BEFORE THE ILLINOIS POLLUTION CONTROL BOARD

SANITARY DISTRICT OF)	
DECATUR,)	
)	
Petitioner,)	
)	
v.)	PCB 09-125
)	(Variance – Water)
ILLINOIS ENVIRONMENTAL)	
PROTECTION AGENCY,)	
)	
Respondent.)

**PETITIONER’S RESPONSES TO THE
ILLINOIS POLLUTION CONTROL BOARD’S QUESTIONS**

Map Identifying Sampling Locations

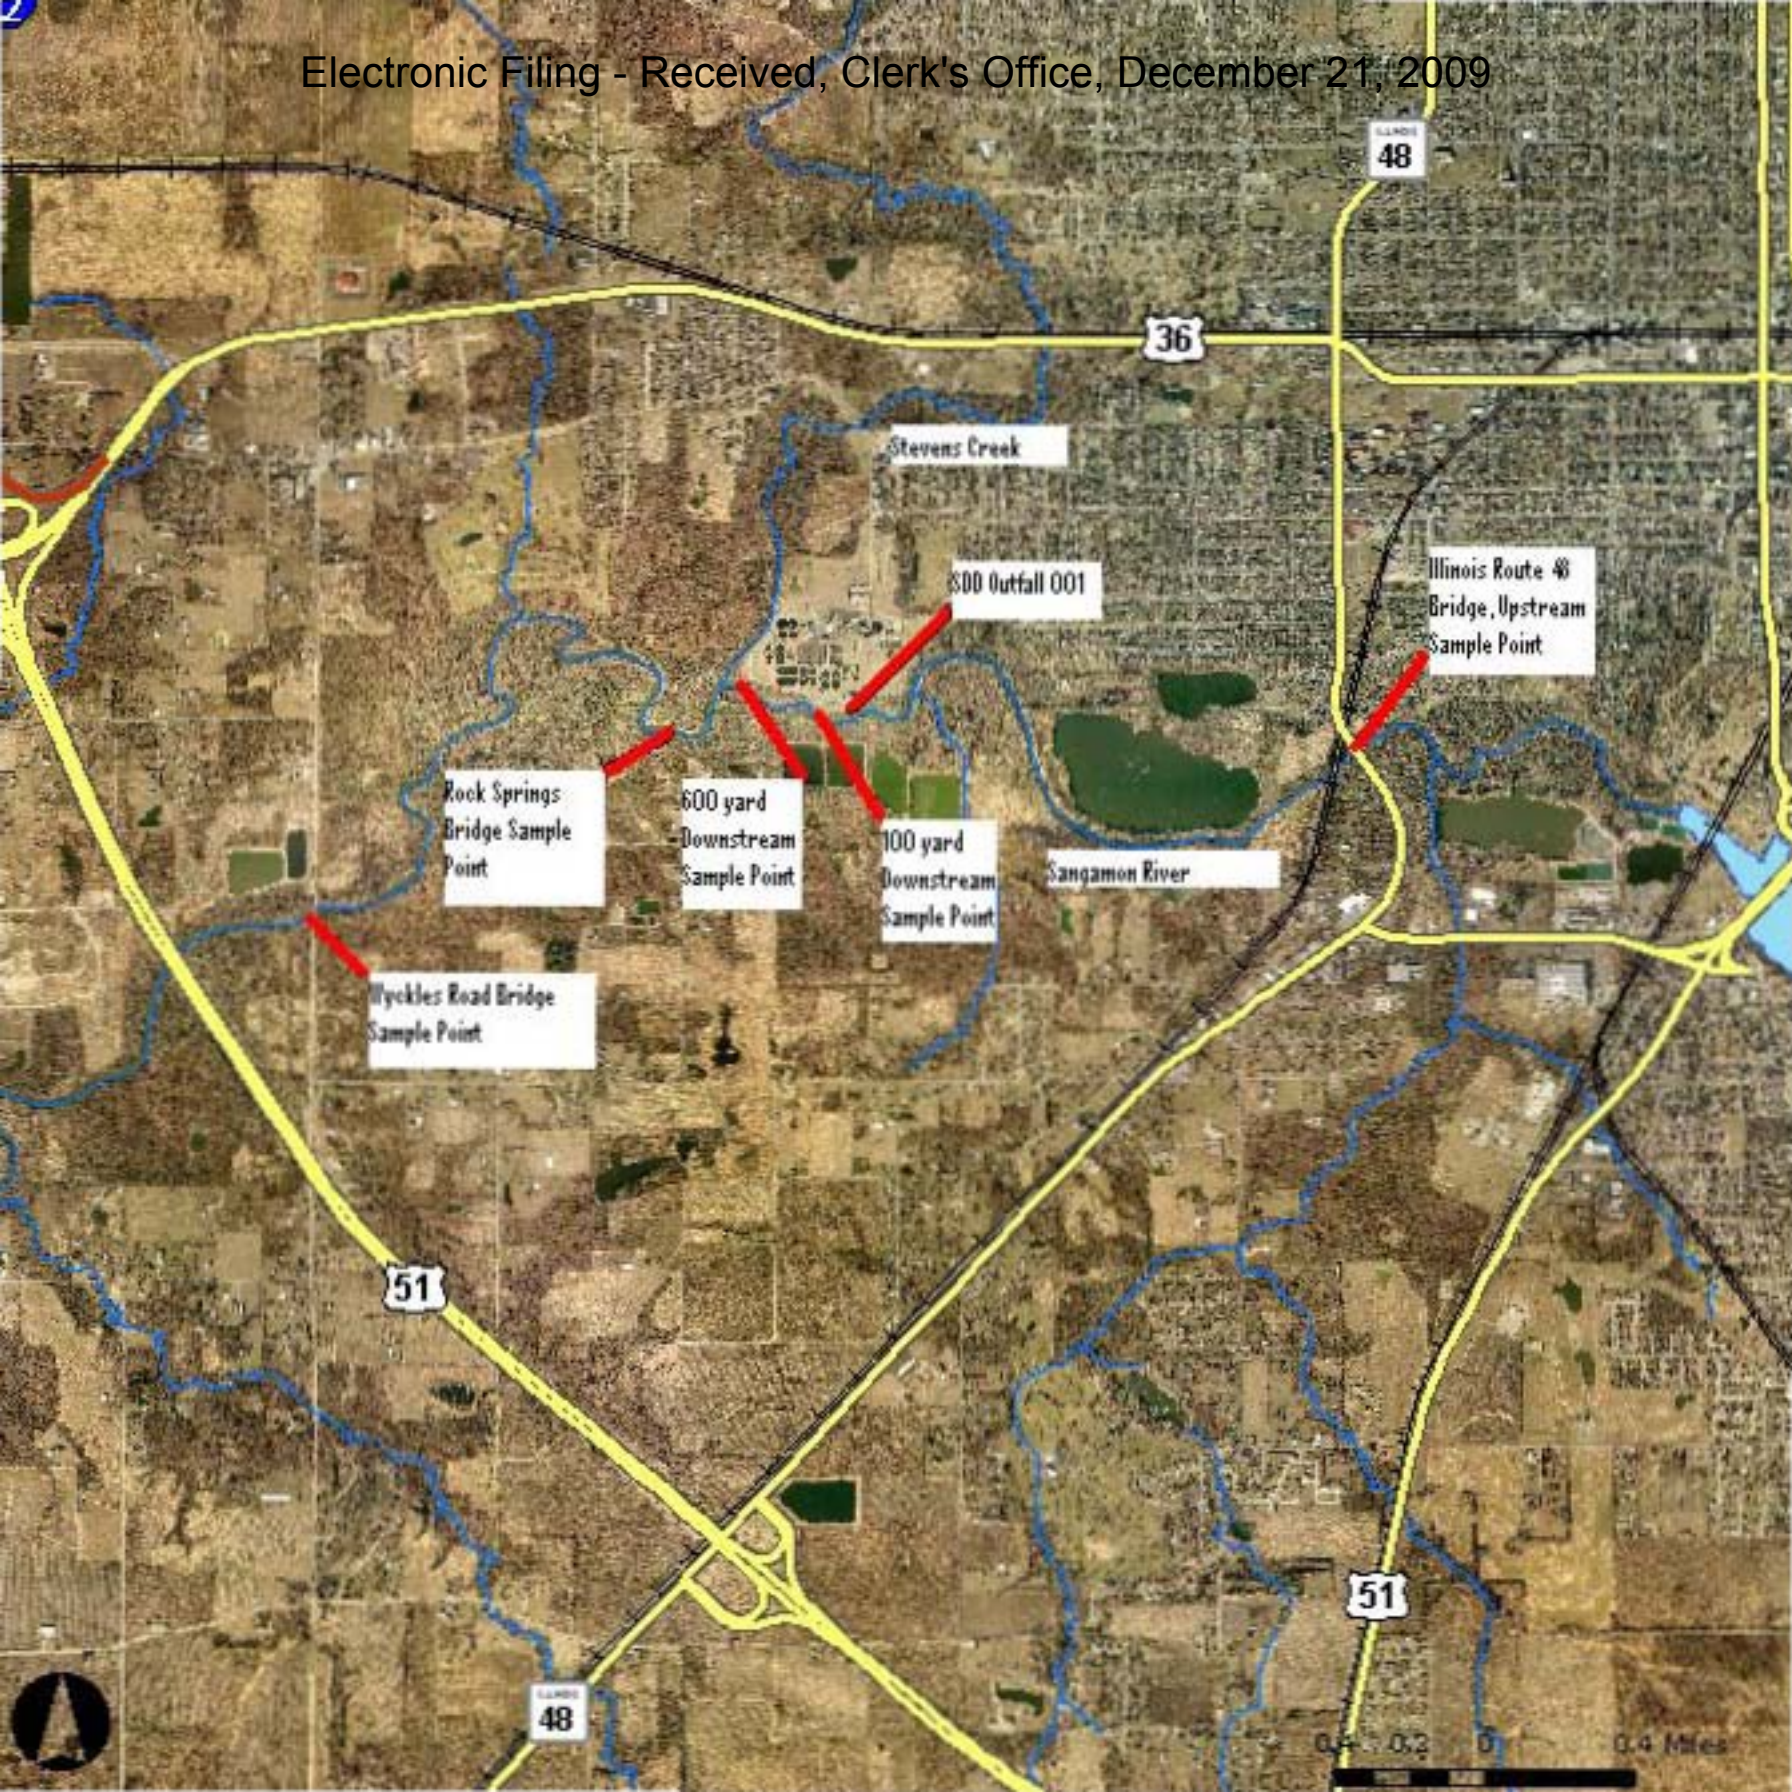
The District provides tables with data from sampling of "River Upstream," "Plant Effluent," "Steven's Creek," and "River Downstream." Pet., Exh. C. The District also states that it will continue "monitoring upstream and downstream of the discharge in the Sangamon River" and that "[d]ownstream monitoring has recently been modified to include four locations in the Sangamon River rather than the one location monitored since 2007." Pet. at 37. Please provide a map identifying all of these sampling locations and the relevant outfall(s). What are the distances from the outfall(s) to the sampling locations?

A map identifying sampling locations is provided (which is attached hereto as Exhibit A). The map shows the southwest portion of the City of Decatur, including a portion of the Sangamon River beginning just downstream of Lake Decatur at the center right and flowing from east to west. Samples described as "upstream" in the Petition

were collected at the Illinois Route 48 Bridge crossing the Sangamon River, approximately two miles upstream of Petitioner's Outfall 001. Petitioner's Main Plant is located near the center of the map, on the north side of the Sangamon River. The downstream sampling point used for many years is the Wyckles Road (County Highway 41) Bridge, approximately three stream miles downstream of Petitioner's Outfall 001. Sampling points added within the past year are approximately 100 yards, 600 yards, and 1000 yards (Rock Springs Bicycle Trail Bridge) downstream of Petitioner's Outfall 001 as shown on the map.
